TO: ALL CUSTOMER ENGINEERS

The attached News Letter is intended to replace all News Letters issued since the announcement of the Model C in January, 1959. All information considered pertinent at this time has been grouped by mechanism for your convenience. This should be particularly helpful to new Customer Engineers who have not received back issues of News Letters.

C. L. Gregoire  
Manager, Customer Engineering,  
Lexington Plant

### SPRING LOADED INNER CARRIAGE TO REDUCE IMPRESSION TROUBLE

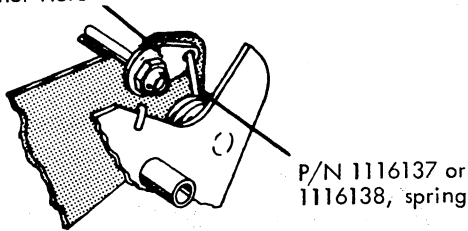
The inner carriage on any Model C may be spring loaded to prevent floating. Install P/N 1116137 (L.H.) and P/N 1116138 (R.H.) new style springs and two spring anchors, P/N 1013363, as shown in the illustration below.

### QUICK INSTALLATION - UNDERPRINTING SHIELDS

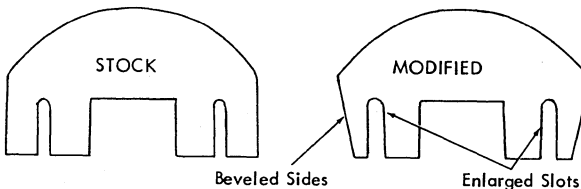
Modify underprinting shields, P/N 1260385, as illustrated for easy insertion and adjustment.

The beveled sides make insertion easier and the enlarged slot makes vertical adjustment easier after the shield is in place.

#### CLUTCH LEVER ASSEMBLY MAY CAUSE LOCK-UPS

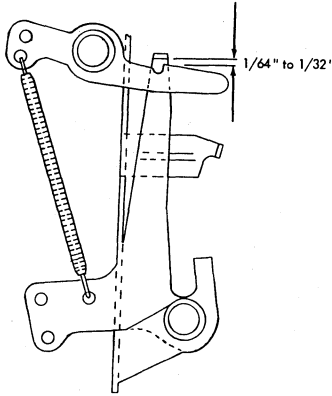
Carriage return lock-up may be caused by distortion of the clutch lever assembly, P/N 1117481. The vinyl plastic sleeve on the anti-whip guard sometimes presses on the power frame. This pressure may distort the clutch lever assembly. Cut the sleeve tip if it is too long. Present production parts are hardened to prevent distortion. Some machines with the soft lever assemblies have a small outer reinforcing bracket, Part No. 1115942, mounted outside the clutch lever bracket with longer clutch lever mounting screws, Part No. 38281.

## RIGHT HAND RIBBON SPOOL GATE

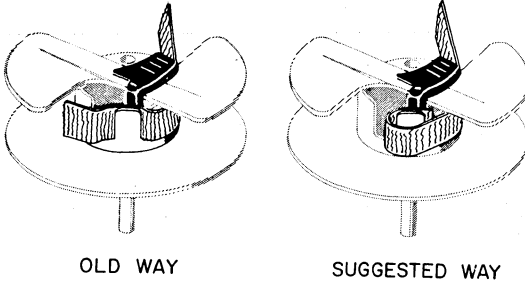
Reports indicate that the gate does not always move freely and therefore may not move into the path of the sensing finger. To free up the gate in those cases where the gate pin appears to be too tight in the spool hole, remove the gate, ream out the spool hole with the six flute bristo wrench (#9900102), and replace the gate.

## MODIFICATION OF RIGHT HAND PLASTIC RIBBON SPOOL

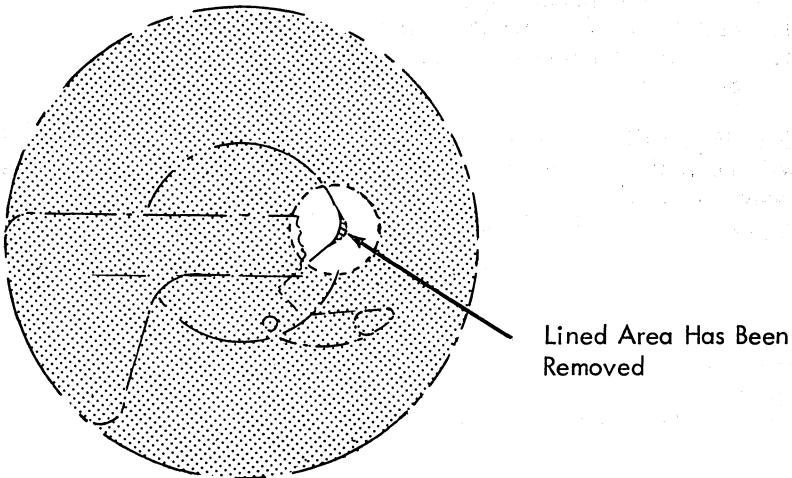
The hub of the spool has been relieved in the area on which the sensing finger rides just prior to entering the gate. This will cause the gate to be forced open insuring ribbon reverse. Former style spools may be similarly relieved with a pocket knife (see illustration).

### CHECK FOR REWIND LEVER BINDS WHEN INSTALLING NEW STYLE RIBBON FEED AND REVERSE SHAFT BEARING

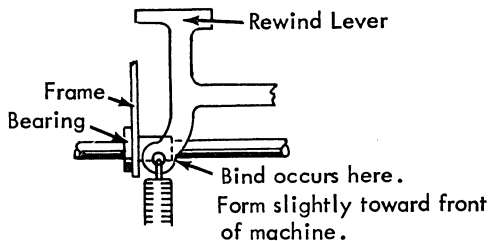
When the new type L.H. ribbon feed and reverse shaft bearing P/N 1118191 is being installed, it may be necessary to slightly form the rewind lever P/N 1118300 away from the new bearing. The rewind lever may bind on the bearing, causing rapid rewind back to the right (see illustration).

## B HEKTOWRITER - CARRIAGE BIND

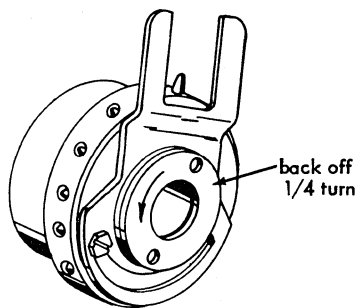
A hard-to-find bind in the Hektowriter auxiliary carriage may be caused by a flat having been worn on the center rollers when a binding condition occurs. Replacement may be necessary.

## ALIGNING WRENCH MODIFICATION FOR WIDE TYPE FACES

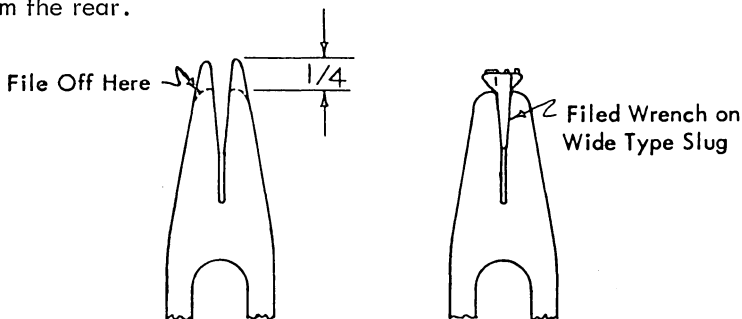
On 4 and 5-unit characters, the type face is often wider than the type slug, preventing the aligning wrench from grasping the type slug from the rear. The aligning wrench may be filed off 1/4" as

illustrated to enable the jaws of the tool to grasp these typebars from the rear.

### HEAVIER SPRING FOR FRONT SCALE

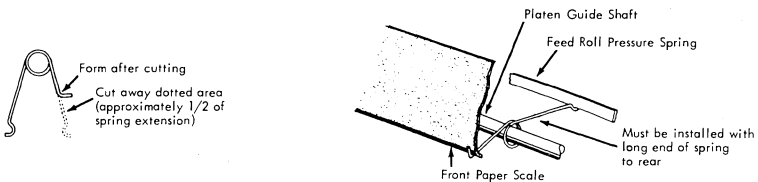
To increase the spring tension on the front scale for pinfeed platen ET's or on ET's that are used for typing stiff cards, a shift buffer spring (P/N 1070017) may be used. Modify and install the spring as shown in the illustration. On pin feed machines one spring may be used under each pin feed finger to prevent the forms from shifting off the pins. Care must be exercised to be sure that the increased spring tension will not offset during normal typing.

### HEAVIER SPRING FOR FRONT SCALE

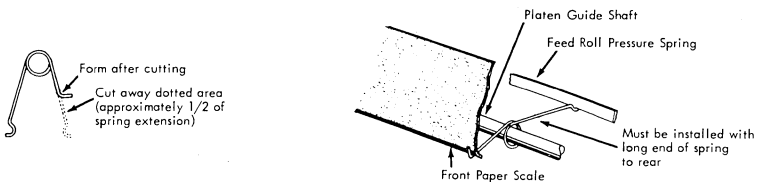
To increase the spring tension on the front scale for pin feed platen ET's or on ET's that are used for typing stiff cards, a shift buffer spring (P/N 1070017) may be used. Modify and install the spring as shown in the illustration. On pin feed machines one spring may be used under each pin feed finger to prevent the forms from shifting off the pins. Care must be exercised to be sure that the increased spring tension will not offset during normal typing.

### DUAL RIBBON REVERSING - SERVICE HINT

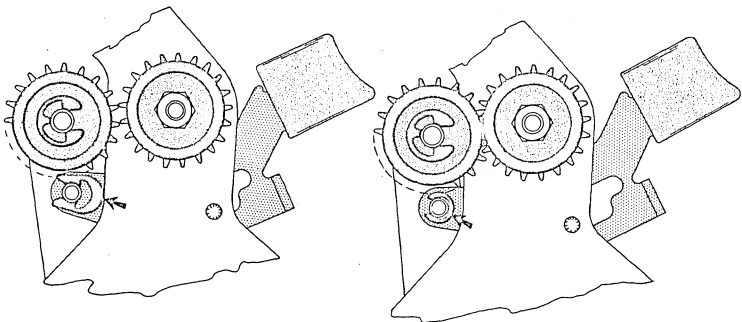
Faulty ribbon reverse on dual ribbon ET's may come from the carbon ribbon rewind release plate being too close to the left hand fabric reverse bracket assembly, preventing the reverse cycle from completing. Form the plate away to obtain the proper clearance and check to see that the lower left ribbon guide does not strike the cover when closed.

## INPRESSION CONTROL SHAFT

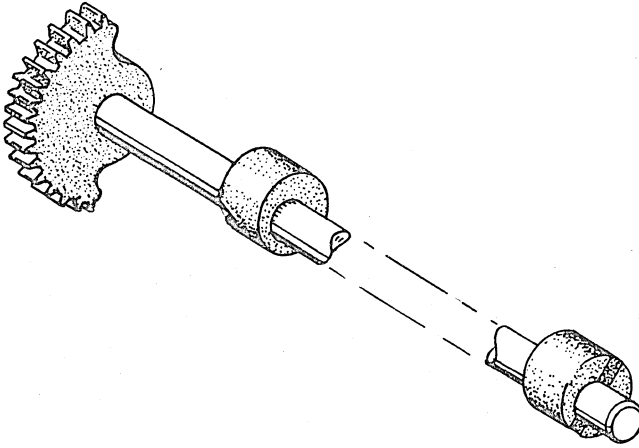
Effective with approximate Standard serial #1406935 and Executive serial #2072562, the impression control shaft (P/N 1115080) has been modified as illustrated. This does not effect the settings of the impression indicator and is interchangeable with the former style.
